STAFF REPORT

REFERENCE: RM080175 (Subdivision) and RM080360 (Land Use)

SUBJECT: **BROWN ACRE VILLAGE LIMITED - REPORT EP09/01/01** - Report prepared for hearing of 12 January 2009

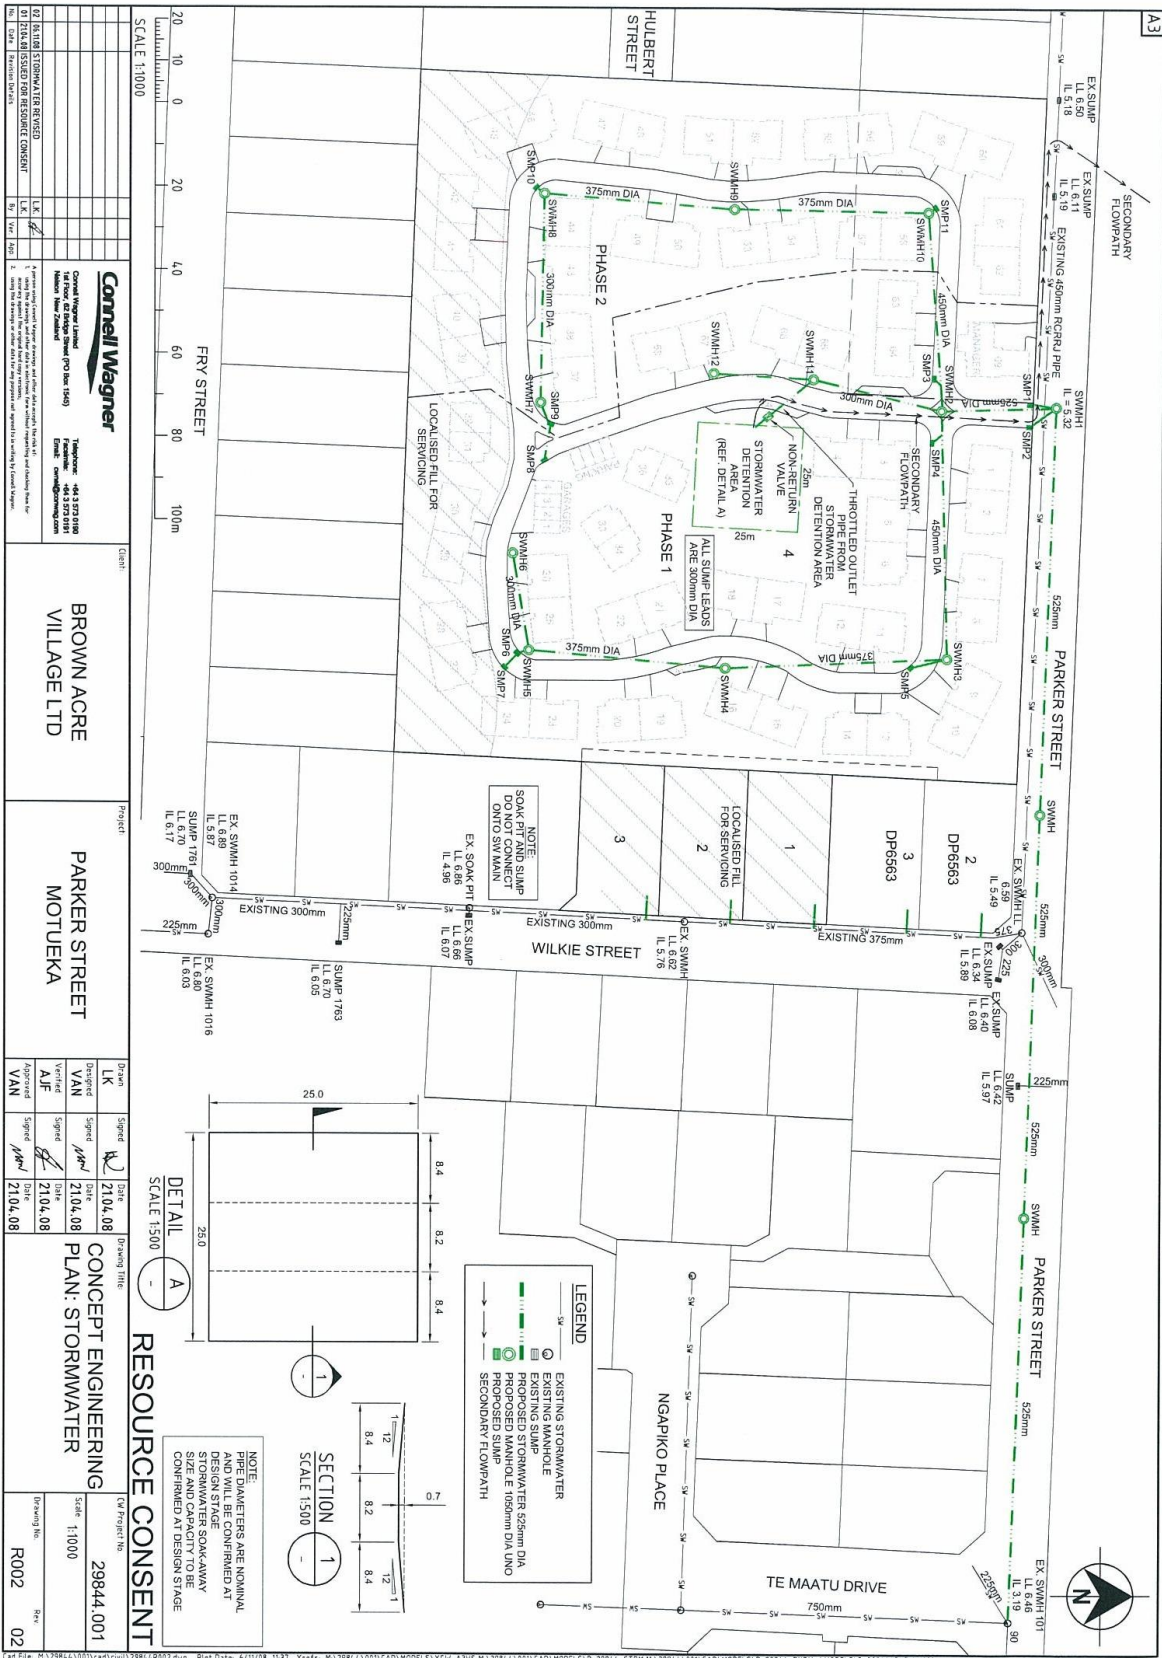
Based on the accepted generated stormwater flows from the development of 386 litres/second (TDC letter of 17 October) there is a need to attenuate the balance of 61 litres/second within the site in the Q₂₀ event. TDC in their letter of 24 September has advised that this is equivalent to 70m³ of storage. In order to provide sufficient additional capacity the detention area has been sized to store a maximum of 200 m³ during the Q₂₀ event.

For simplicity a footprint of 25 m x 25 m has been adopted and is shown on the concept plan. During final design it is likely that a shape more in keeping with the overall aesthetics of the Village Green will be adopted. This will not affect the design detention volume, which will remain at 200m³ at Q₂₀.

The proposed scheme is shown on amended drawing R002.

Secondary flowpath is required for all flows over the Q₂₀ event. The proposed secondary flowpath makes use of the existing low overflow channel that crosses Parker Street at the northwestern corner of the site. This approach is consistent with that identified in Item 4 of TDC letter of 24 September. Secondary flowpaths within the development will be along the proposed internal road, which will fall from south to north towards Parker Street. A secondary flowpath will be provided for the detention pond in the vicinity of the parking area on the eastern side of the central internal road. The proposed flowpath is shown on amended drawing R002.

4. Sewer

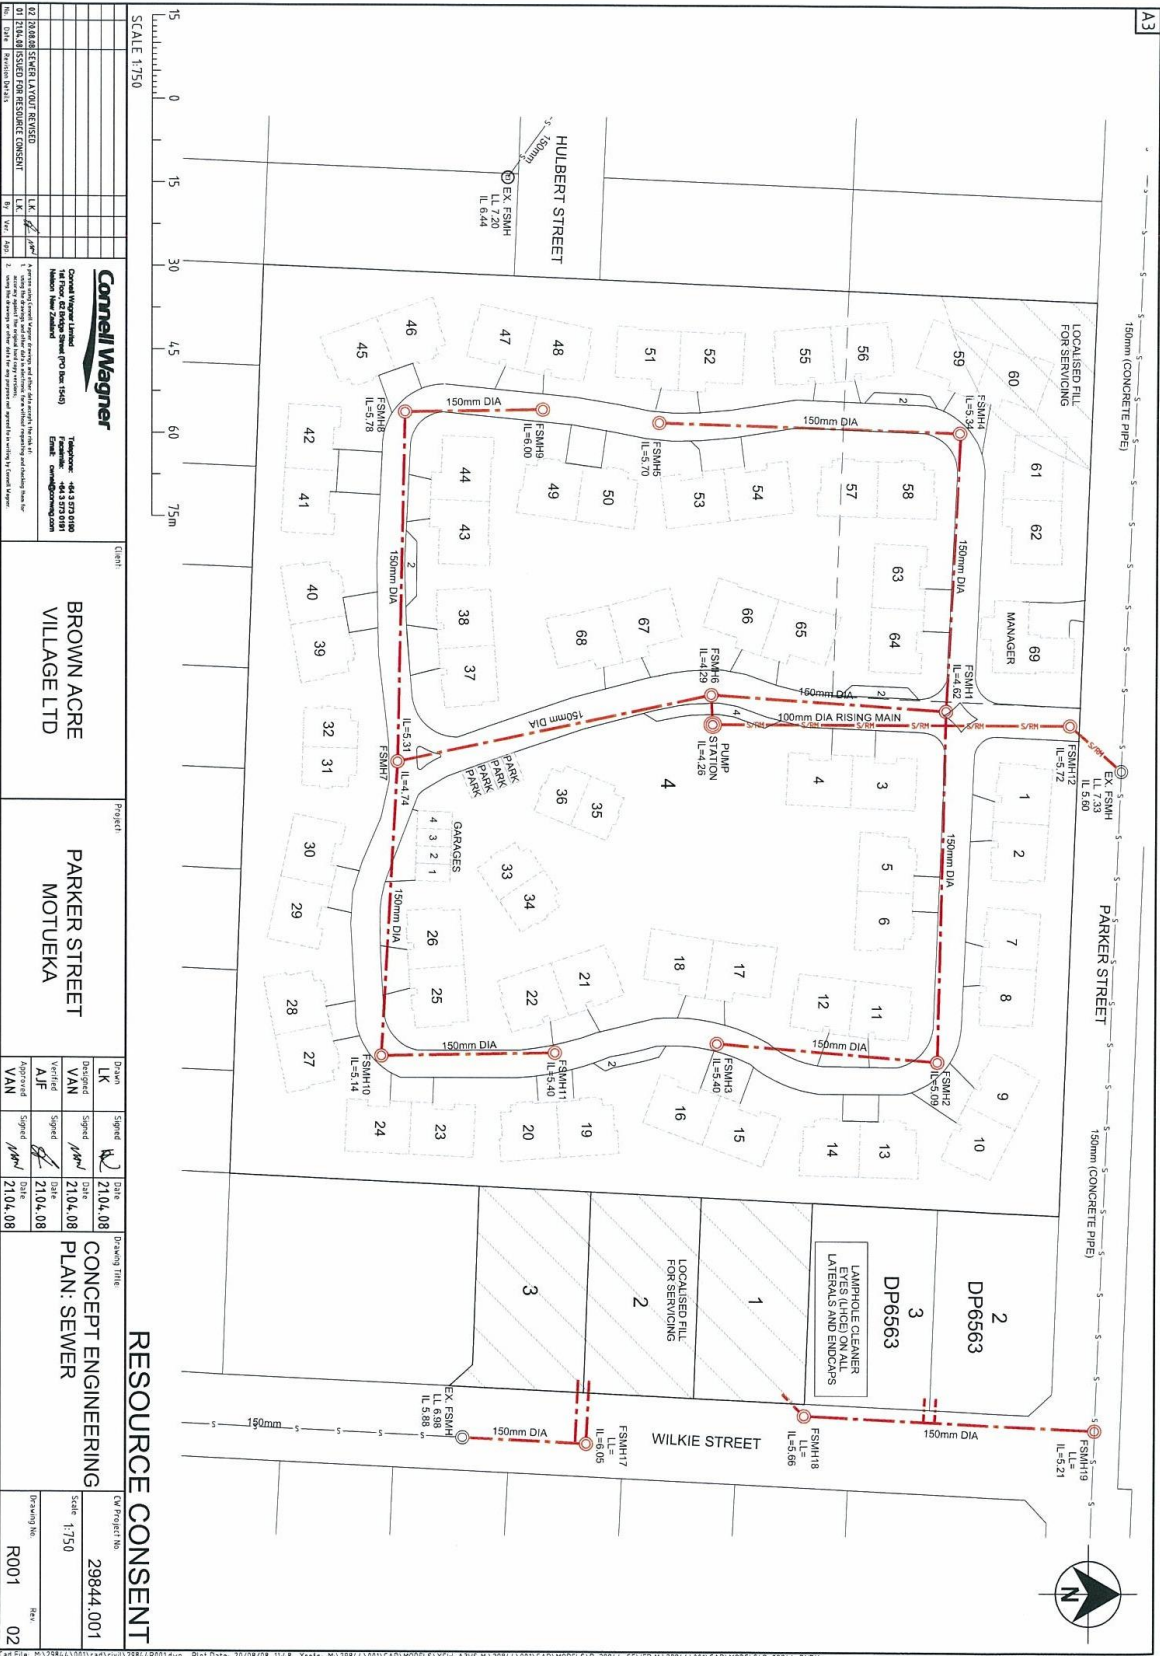
There has also been changes to the proposed sewer concept. The previous proposal was for a sewer pump station to be incorporated adjacent to Wilkie Street in the vicinity of proposed Lot 3. The current scheme has the pump station sited within the site in the vicinity of the Village Green area. From the pump station there will be a connection into the existing 150 mm sewer on Parker Street. There have also been some minor amendments to the servicing of the two existing lots (Lots 2 and 3 DP 6563) and the three proposed lots (1, 2 and 3) on the Wilkie Street frontage. The proposed scheme is shown on amended drawing R001.
